AS BUILT

designed for		R.De Salvo	
draw. by		G. Gennaro-PROMECA	
date	9-01-05	scale	1/2
title		HAM-OPTICAL BENCH	
		INVERTED PENDULUM	
detail from	107		A 2

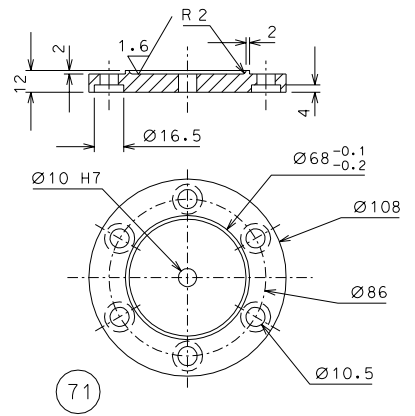
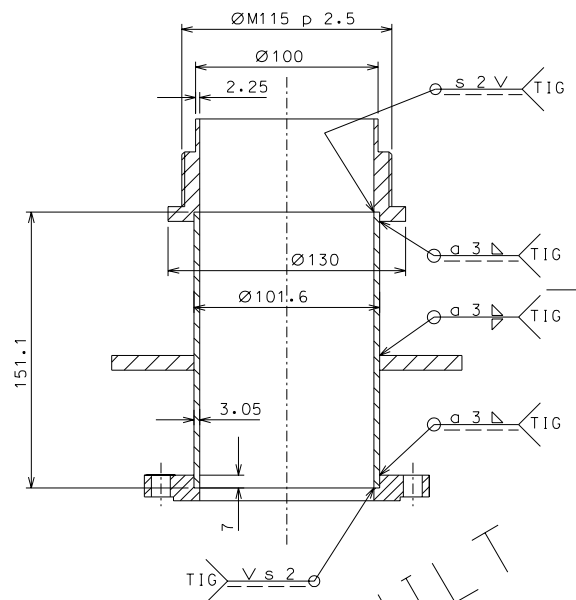
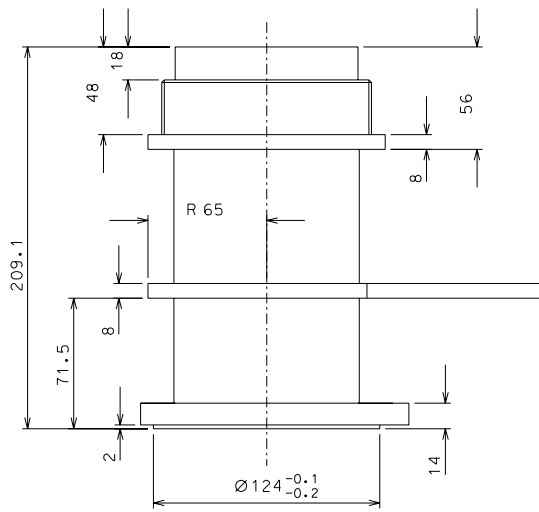
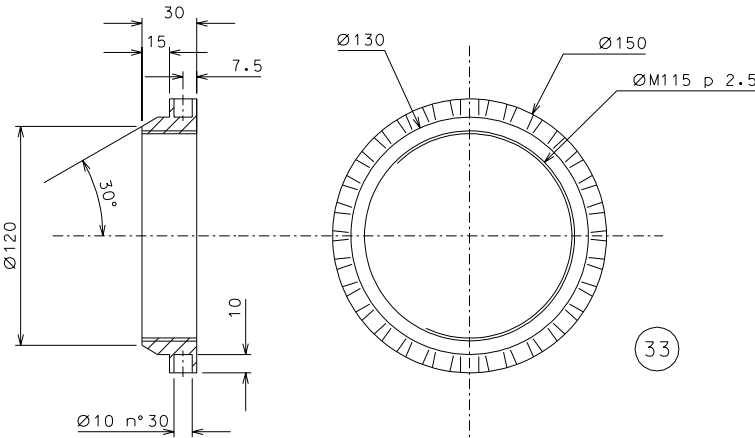
changed type of welding	17-08-06		
changed material part 33	17-08-06		
modified part 32	19-06-06		
added dimension	07-04-06
